HISTORIC AND DESIGN REVIEW COMMISSION

June 29, 2022

HDRC CASE NO: 2022-338
ADDRESS: 3304 BROADWAY
LEGAL DESCRIPTION: NCB 6142 BLK LOT S IRR 97 FT OF 47 & NCB 3859 BLK 5 LOT 1 THRU 3
ZONING: C-2, RIO-1
CITY COUNCIL DIST.: 2
APPLICANT: Justine Huang/Michael Hsu Office of Architecture
OWNER: Patrick Terry/Terry Enterprises LLC
TYPE OF WORK: New construction, signage
APPLICATION RECEIVED: June 03, 2022
60-DAY REVIEW: Not applicable due to City Council Emergency Orders
CASE MANAGER: Edward Hall
REQUEST:

1. Construct a one story, commercial structure at 3304 Broadway, located within the River Improvement Overlay, District 1. The proposed development will feature on-site parking and outdoor dining space. The proposed new construction will feature 2,697 square feet.

SITE
PLAN

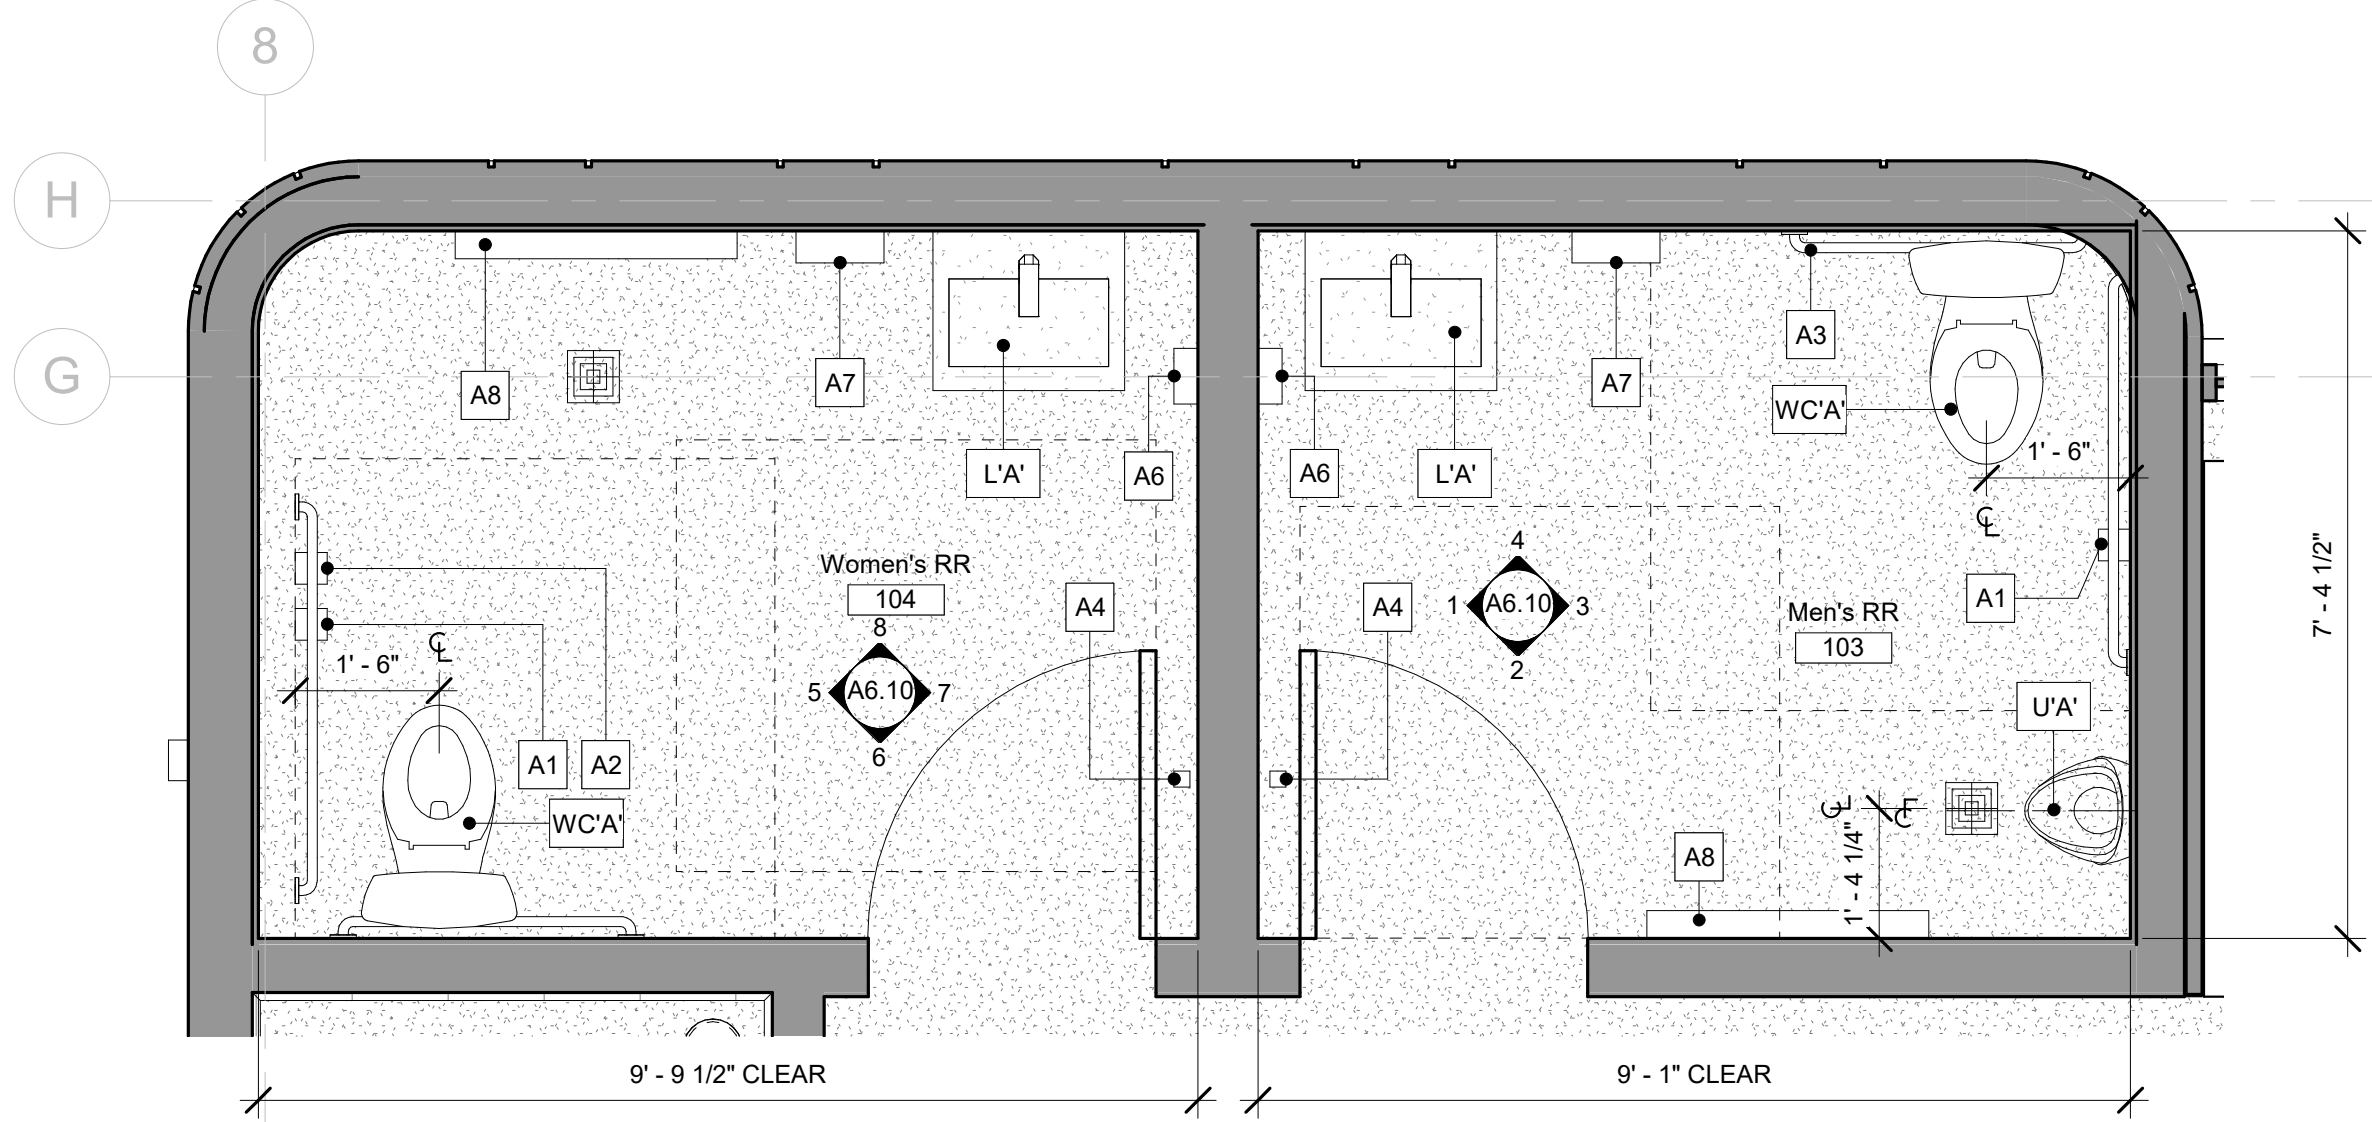
- c. PEDESTRIAN CIRCULATION – Per the UDC Section 35-672(a), in regards to pedestrian circulation, an applicant shall provide pedestrian access among properties to integrate neighborhoods. The applicant has provided a site plan which notes the connection of various functions of the site in a coordinated system. This is consistent with the UDC.

- d. AUTOMOBILE ACCESS – Regarding automobile access and parking, the UDC notes that automobile circulation should be efficient to minimize conflicts with pedestrians. Curb cuts should be limited to one on each street face not exceeding twenty-five (25) feet in width each. The applicant has proposed one curb cut that

is to feature twenty-five feet in width. Staff finds the proposed location of the curb cut to be appropriate and finds the width to be appropriate and consistent with the UDC.

- e. **PARKING LOCATION** – Per the UDC Section 35-672(b)(2), parking areas should be located toward the interior of the site or side or rear of the building. Additionally, parking locations must be screened if located within twenty foot setback from a property line adjacent to a street use per type B listed in table 510-2 of the UDC. The applicant has noted parking at the rear of the site, behind the proposed new construction. Staff finds the proposed parking location to be appropriate and consistent with the UDC.

- g. **STREET FURNISHINGS** – The applicant has noted the location of outdoor seating per the site and floor plans. The applicant is responsible for complying with the UDC Section 35-673(i) in regards to street furnishings. Information regarding street furnishings is to be provided to staff for approval.

1. Staff recommends approval based on findings a through n with the following stipulations:
 - i. That a detailed landscaping plan be submitted to OHP staff for review and approval
 - ii. That all street furnishings and patio furniture be submitted to OHP staff for review and approval.
 - iii. That an architectural/site lighting plan be submitted to OHP staff for review and approval.
 - iv. That the dumpster enclosure feature an architectural finish, and not simply unfinished or painted CMU.
2. Staff recommends approval of item #2, wall sign A, as submitted, based on finding p.
3. Staff recommends approval of item #3, wall sign B, as submitted, based on finding p.
4. Staff recommends approval of item #4, vehicular signs C1 & C2, as submitted, based on finding r.

Exterior Elevations

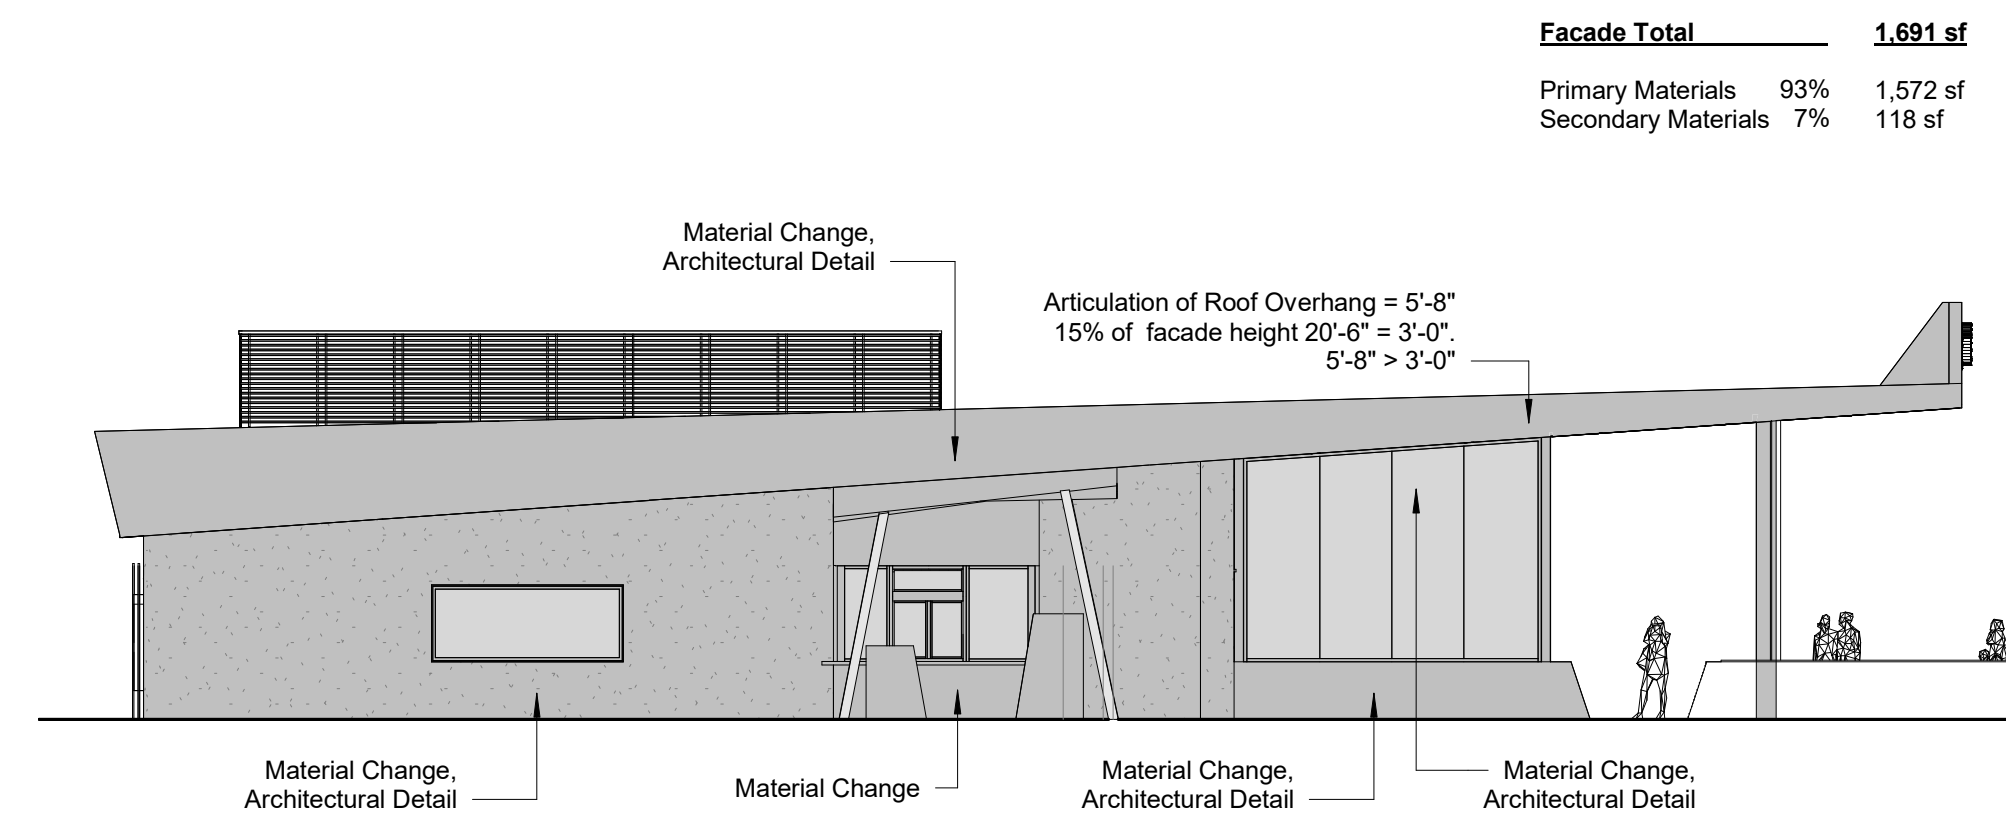
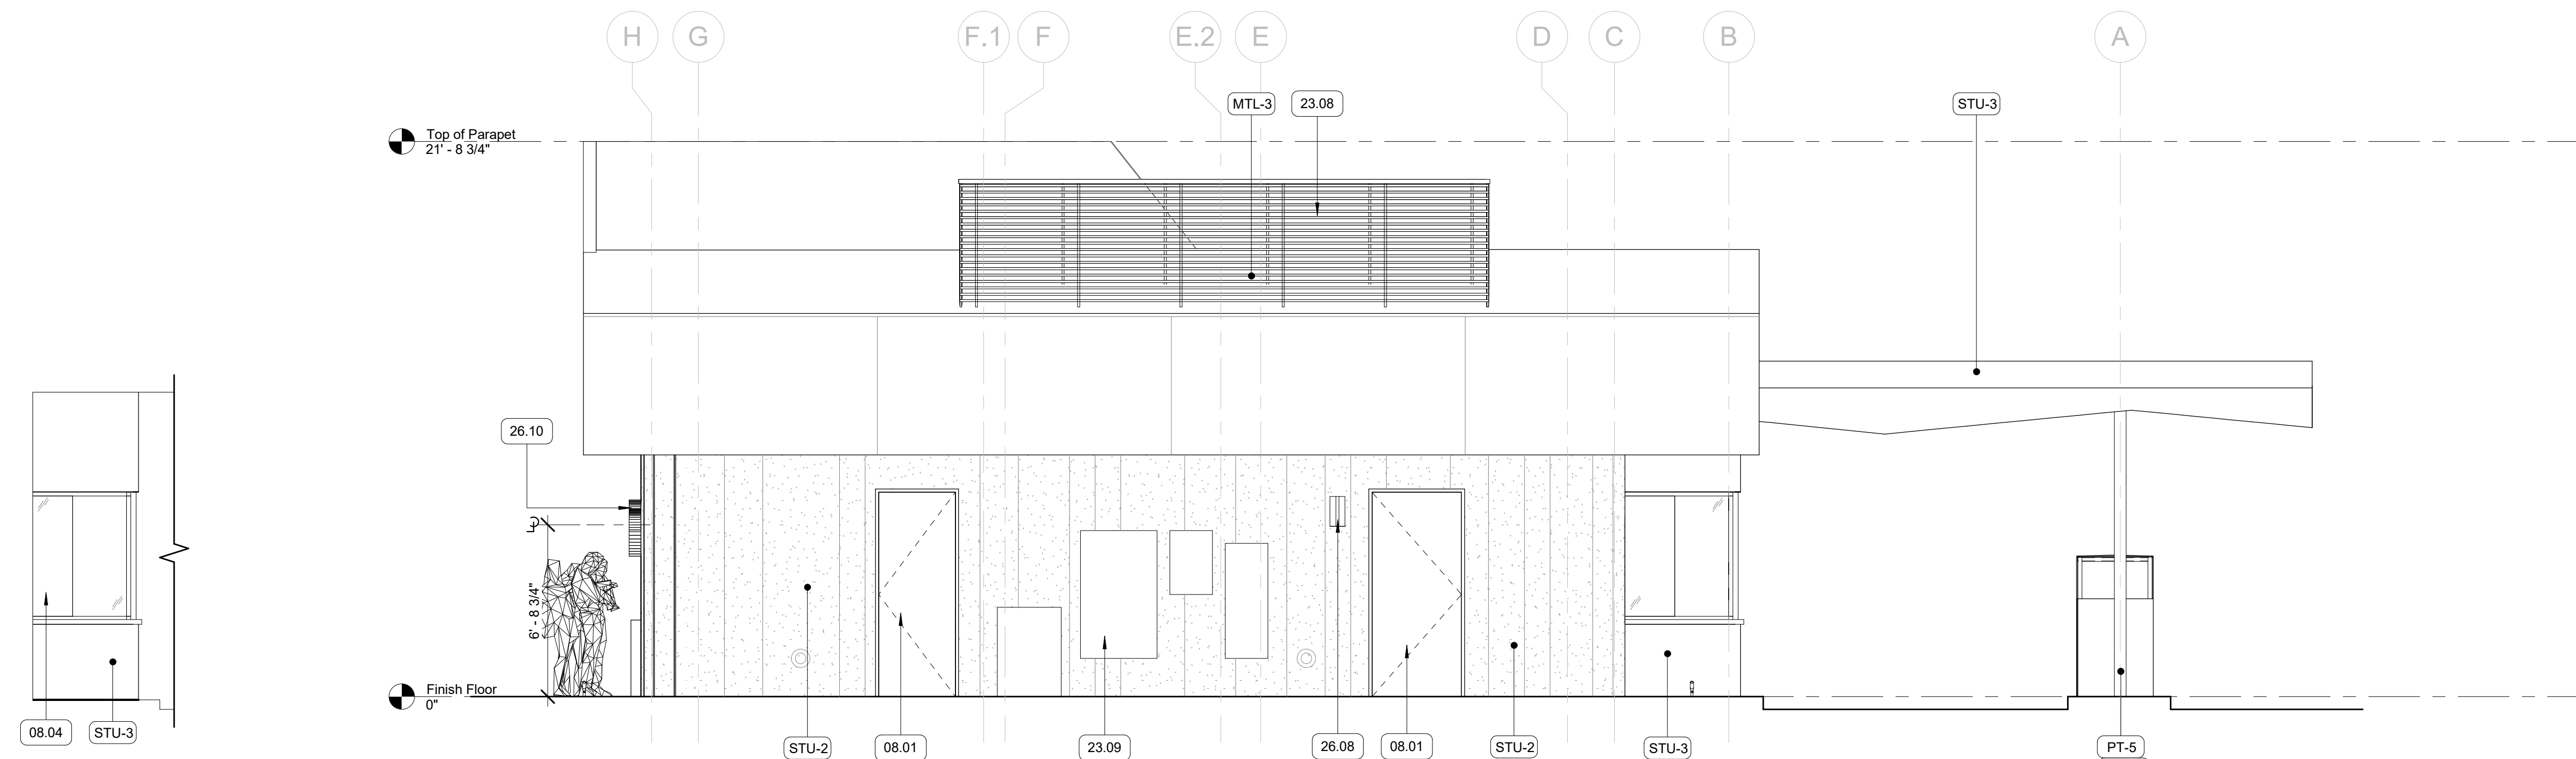
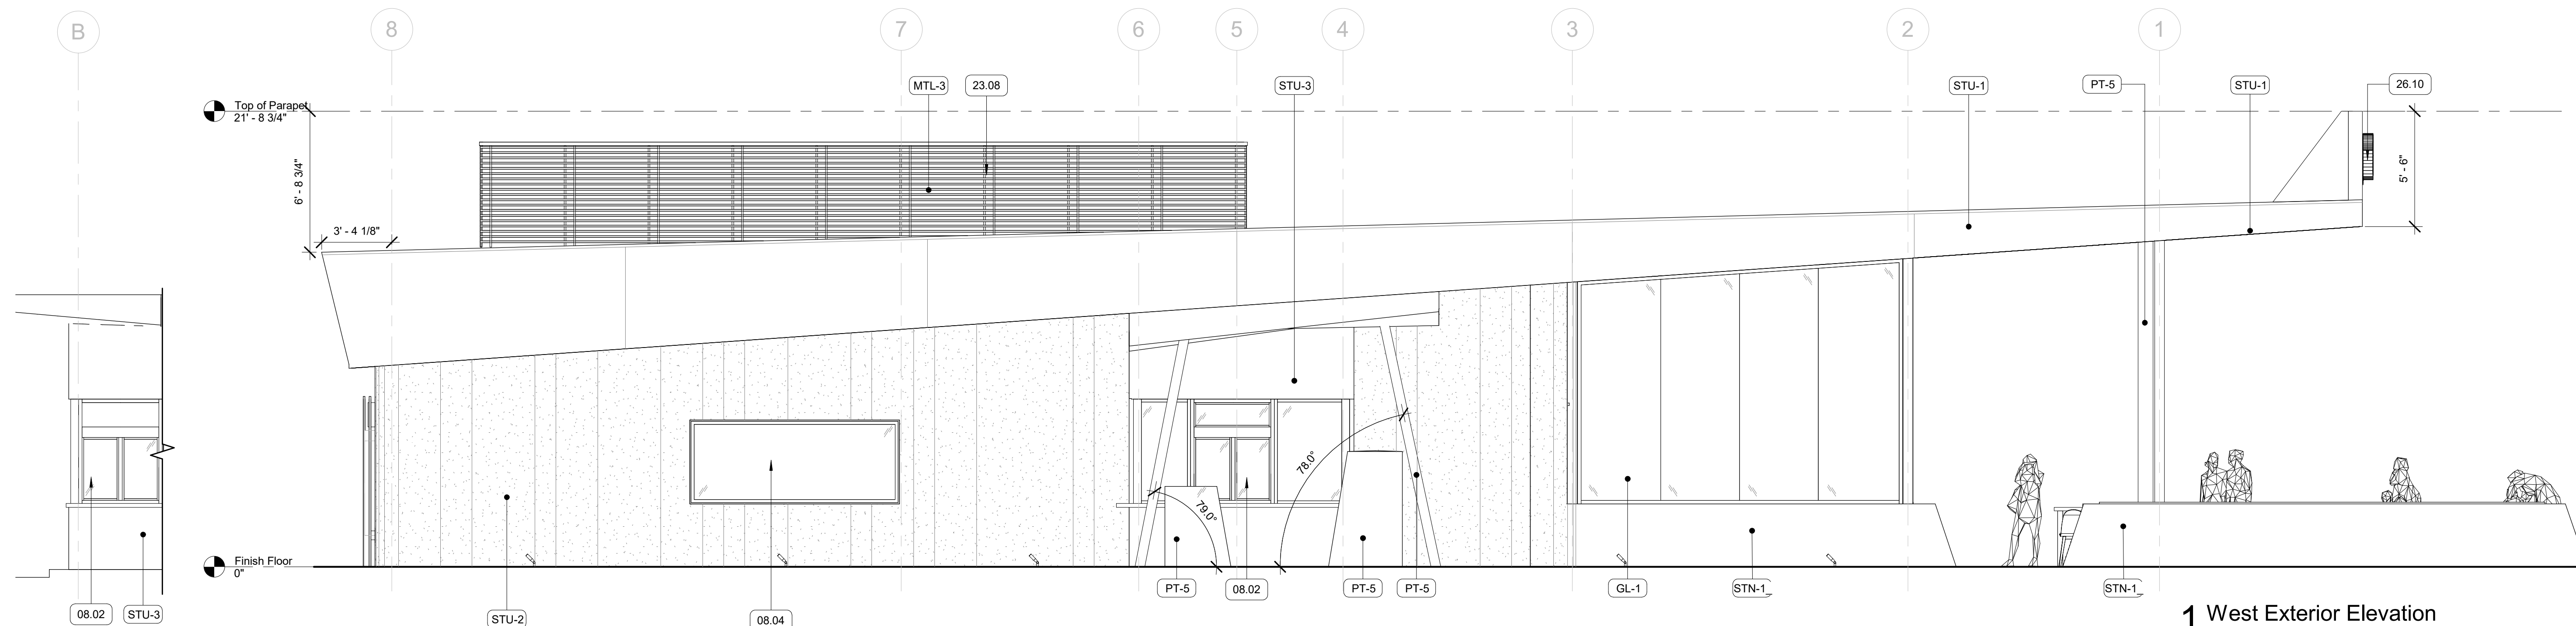
- n. **FAÇADE COMPOSITION** – According to the UDC Section 35-764 (e), building facades located in the River Improvement Overlay must be organized into three distinct segments; a base, mid-section, and a cap. Staff finds that the applicant has met these standards of the UDC by using varying building forms and planes, changes in materials, and changes in material colors.
